BID ADDENDUM #2

DATE: May 30th, 2023
PROJECT: 15th Street Extension
PROJECT P.I. NO. 0015019
NUMBER:

SPECIAL CONSTRUCTION DETAIL
15TH STREET EXTENSION
MIDTOWN ATLANTA GUIDELINES

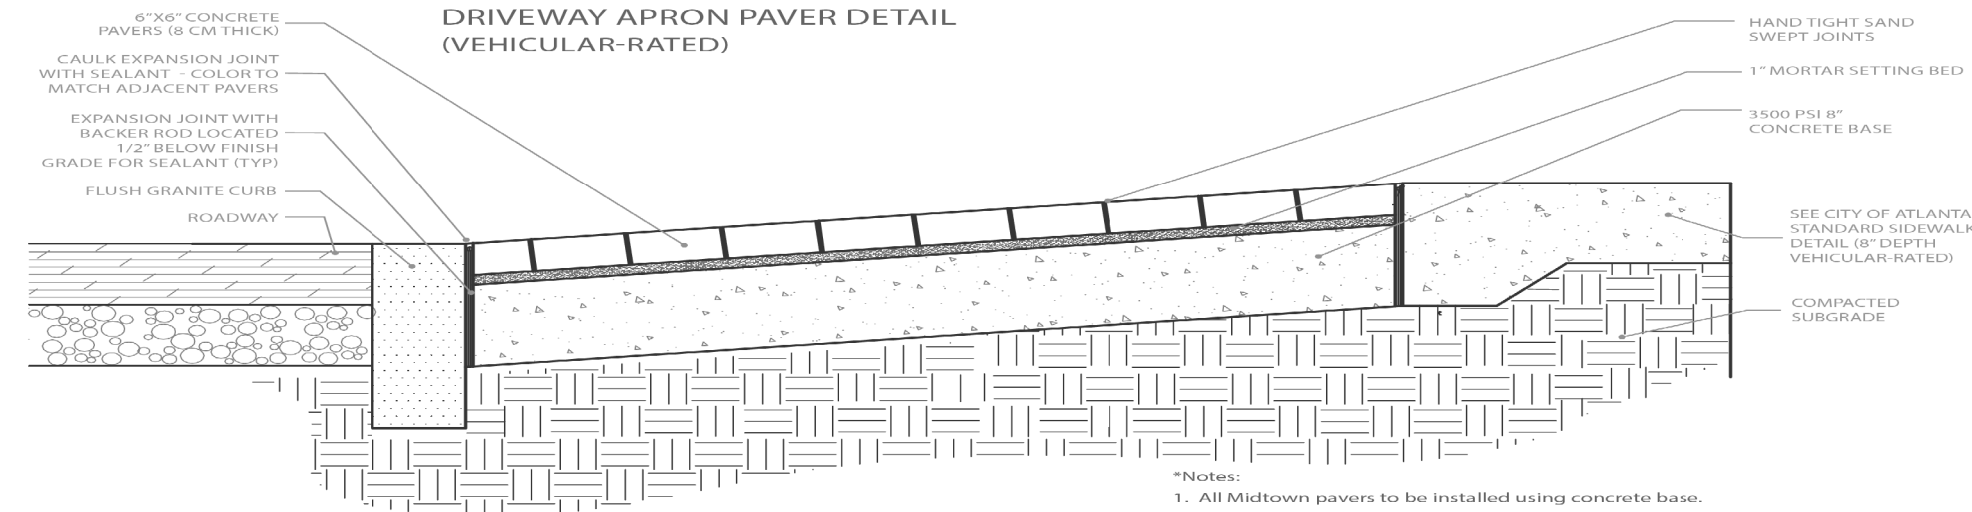
10. **Question:** Can a detail be provided for the proposed concrete pavers?

Answer: Concrete paver detail added to Sheet 38-0009.
